**SUBJECT:** PB 2018-16 Application of Dimovski Architecture, for the property of AT&T Montrose, for Site Plan approval for a proposed 2,500 gallon above ground fuel oil tank to replace an existing underground fuel storage tank located at 7 Trinity Avenue.

REVIEW MEMORANDUM

To: Town of Cortlandt Planning Board  
Cc: Chris Kehoe, AICP – Deputy Director – Planning, Department of Technical Services  
Tom Wood, ESQ. – Town Attorney / Michael Cunningham, ESQ. – Dept. Town Attorney  
From: Michael Preziosi, P.E. – Director, Department of Technical Services  
*Michael Preziosi, P.E.*  
Date: July 25, 2018  
RE: PB 2018-16 AT&T – 7 Trinity Place, Montrose NY

**PROJECT: AT&T 7 Trinity Place  
Montrose, New York**

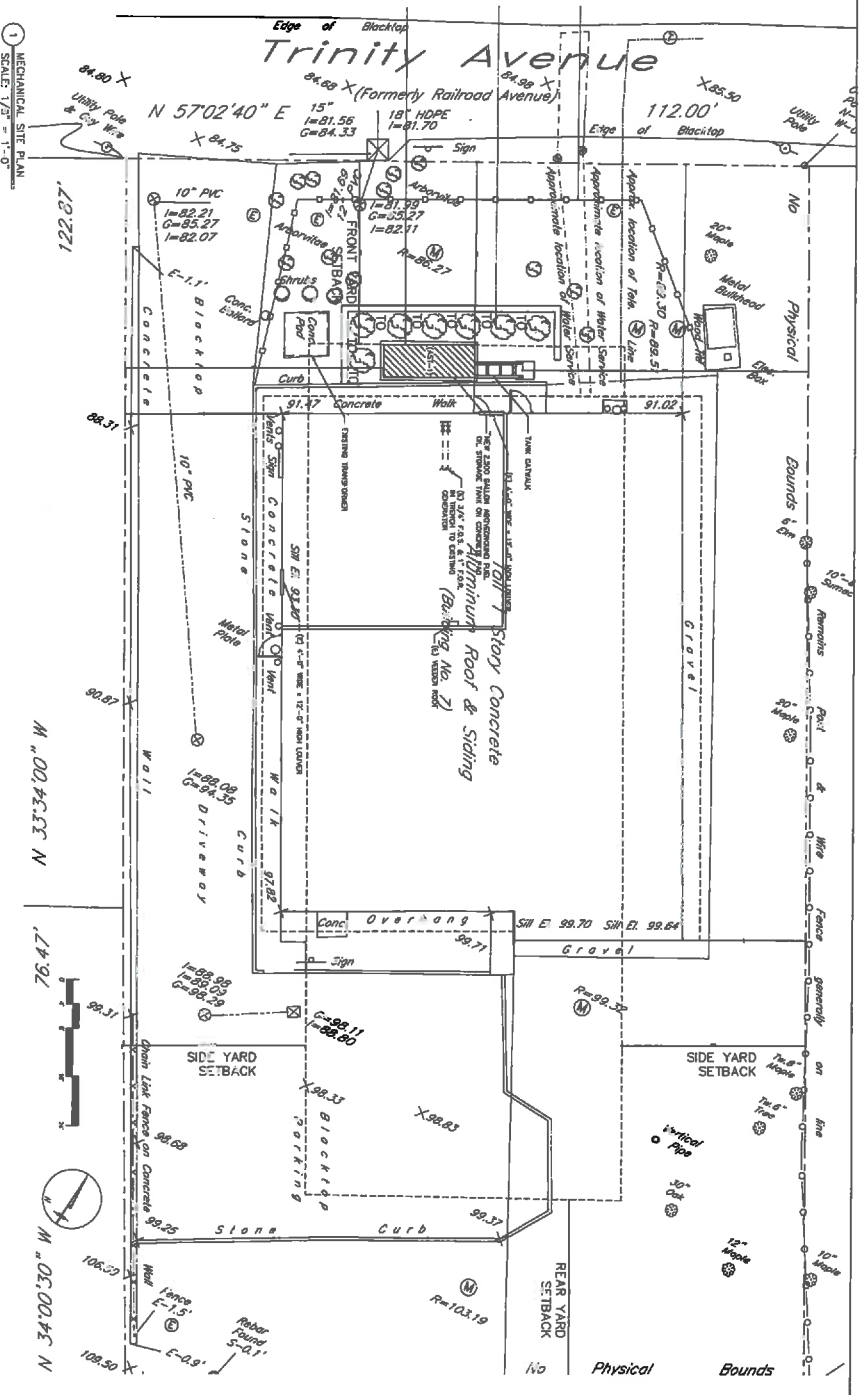
Item #2.

- We are providing photographs of the site and nearby buildings on adjacent properties.
- Detail of the proposed concrete pad.
- Detail for the proposed arborvitae screening.

1 MECHANICAL SITE PLAN  
SCALE: 1/8" = 1'-0"

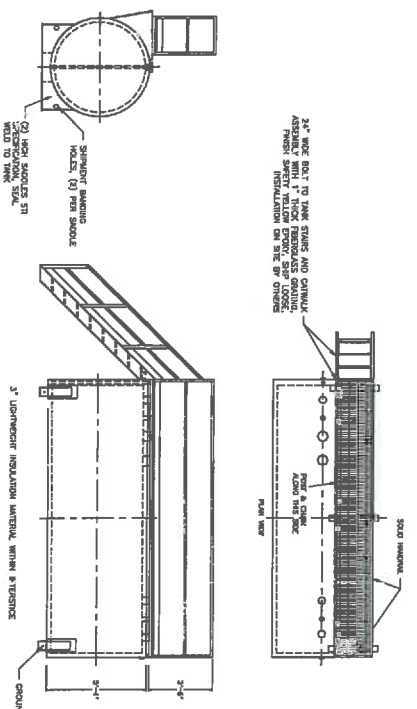
- b. Provide north arrow.
    - *North arrow provided.*
  - c. Indicate location of all exterior doors and windows near proposed oil tank.
    - *See drawing M101.*
